KEENE INFRASTRUCTURE IMPROVEMENTS **PHASE 2 PRELIMINARY DESIGN REVIEW FOLLOW-UP**

MSFI COMMITTEE MEETING

JUNE 26, 2024

EXISTING ELEMENTS

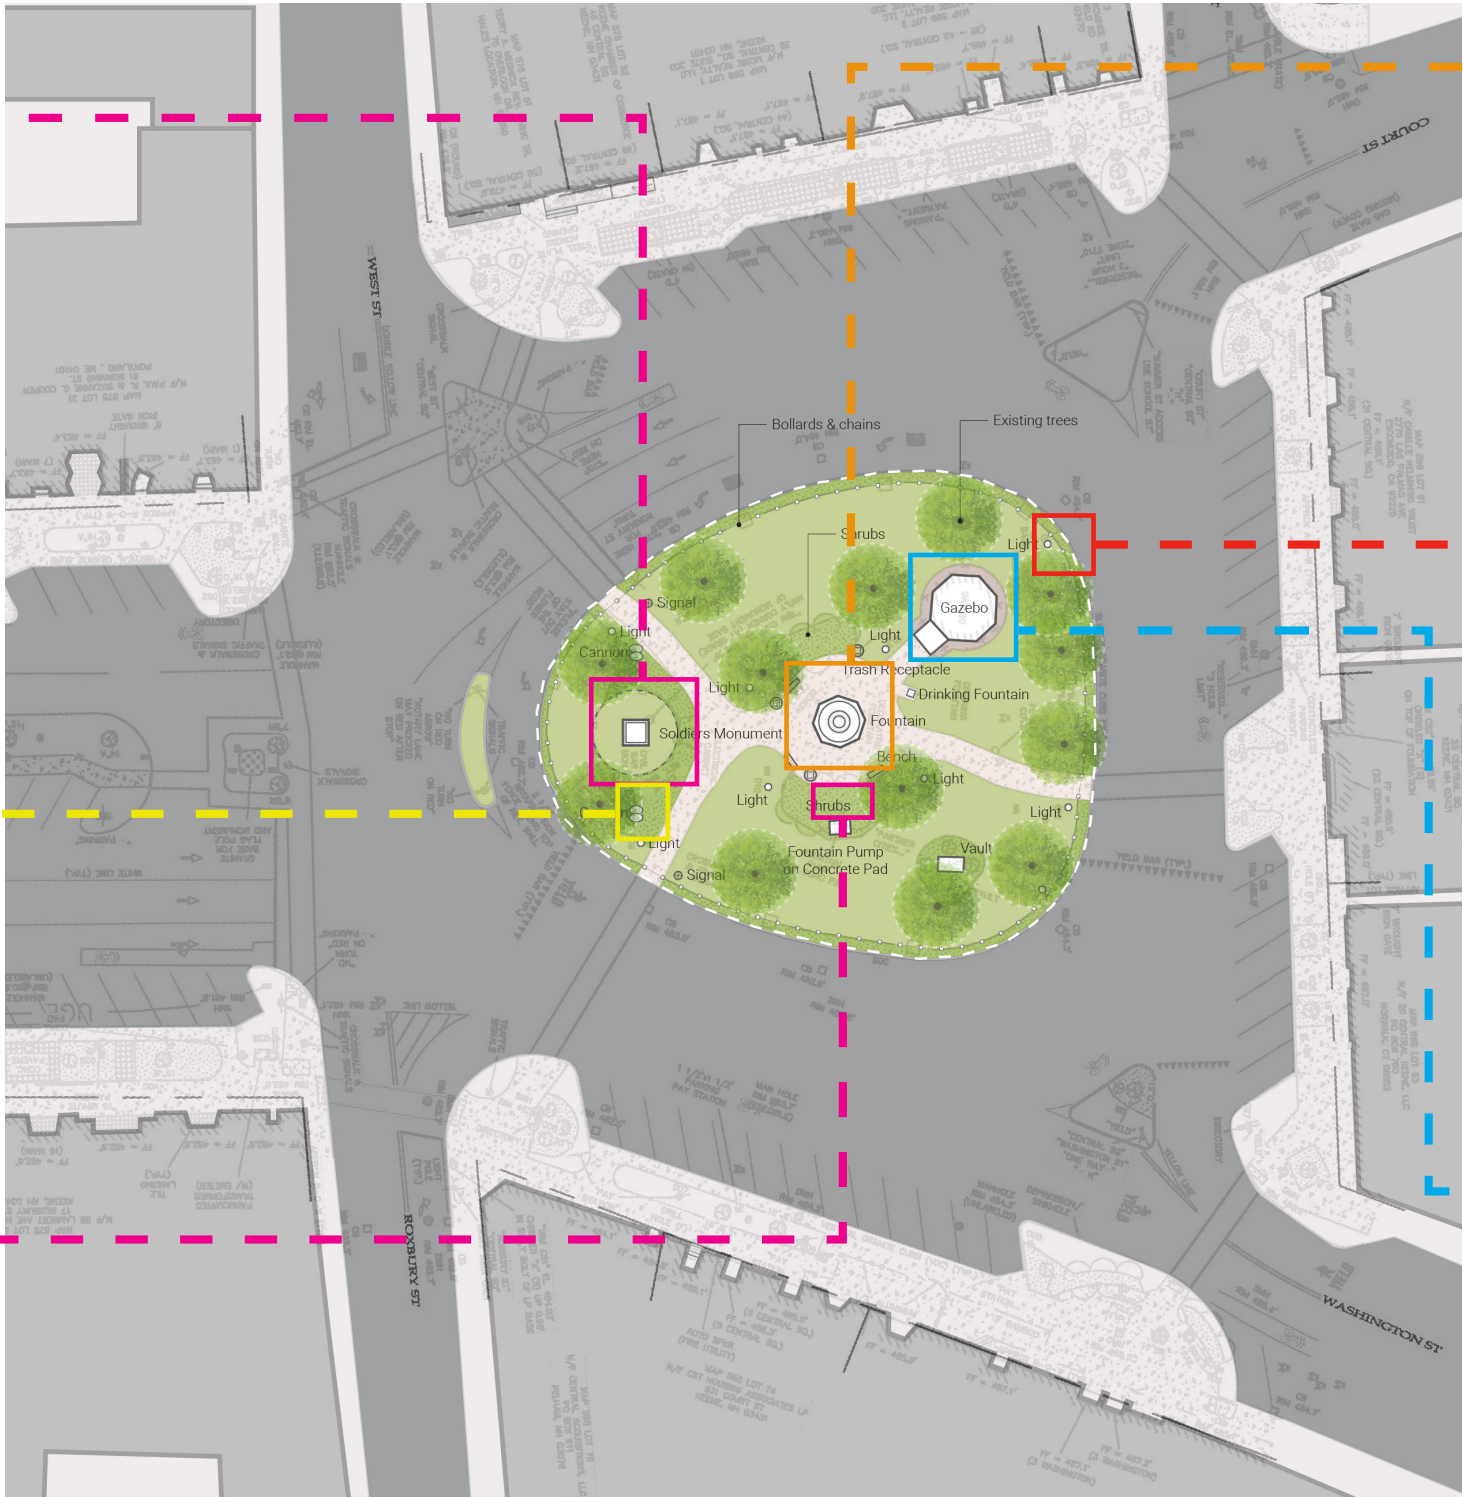
Soldiers' Monument - Should statue be moved out to the nose to be more prominent?

Cannon - Should cannon/cannonballs be moved out to the nose to be more prominent?

Bench - Should more bench seating be provided?

Bollard - Granite post and chain detail to be moved to perimeter?

Gazebo/Bandstand - Should Gazebo/bandstand be moved to provide more space around it? prominent?
